Project description . . : REPAIR/RESTORATION OF BUILDING EXTERIOR
 Project number . . . : 95- 10100091
 Case Number : H-95-91
 Project type : HISTORIC DESIGN REVIEW BOARD
 Application date . . : 06/19/95

DATE: 11 July 1995
TO: Historic Design Review Board Members
FROM: Mary Grzeskowiak, Planner III *MG*

CASE #H-95-91 ADDRESS 515 PASEO DE PERALTA

Re: 515 Paseo de Peralta, Area #1, House #533, "Significant".

JOB 515 San de Peralta (Gabel)
SHEET NO. 1 OF 2
DATE 6-17-95
DATE _____

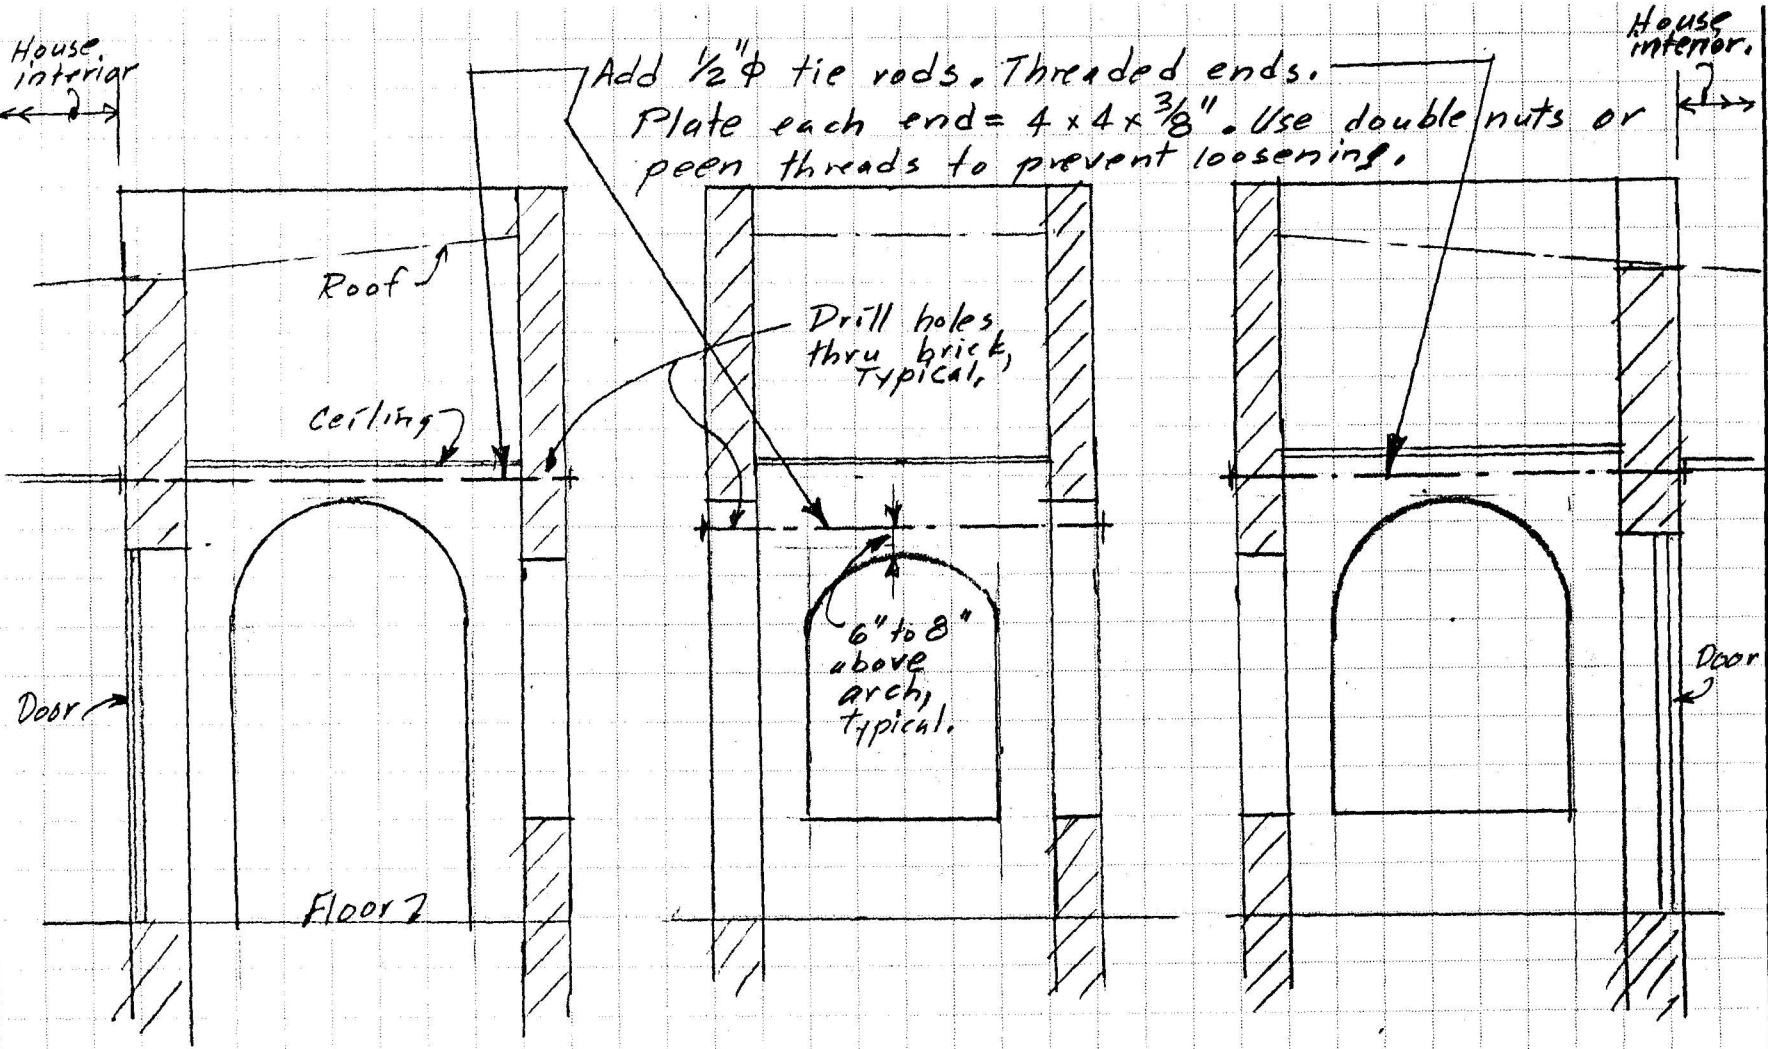
As illustrated in the structural engineering assessment and drawing, the tower feature will be shored with tie rods, and the missing areas of brick work patched and filled before restuccoing. In addition the applicant has indicated that modern features on the exterior of the building (eaves, window frames, and doors) will be scraped, repaired/replaced to match the existing, and repainted.

?
should
be expandable
?
(freeze
thaw
cycle)

1. Drill & install tie rods. Snug up on nuts.
2. Fill & patch all cracks & holes in walls of entry.
3. Re-tighten and set nuts just before new stucco is applied.
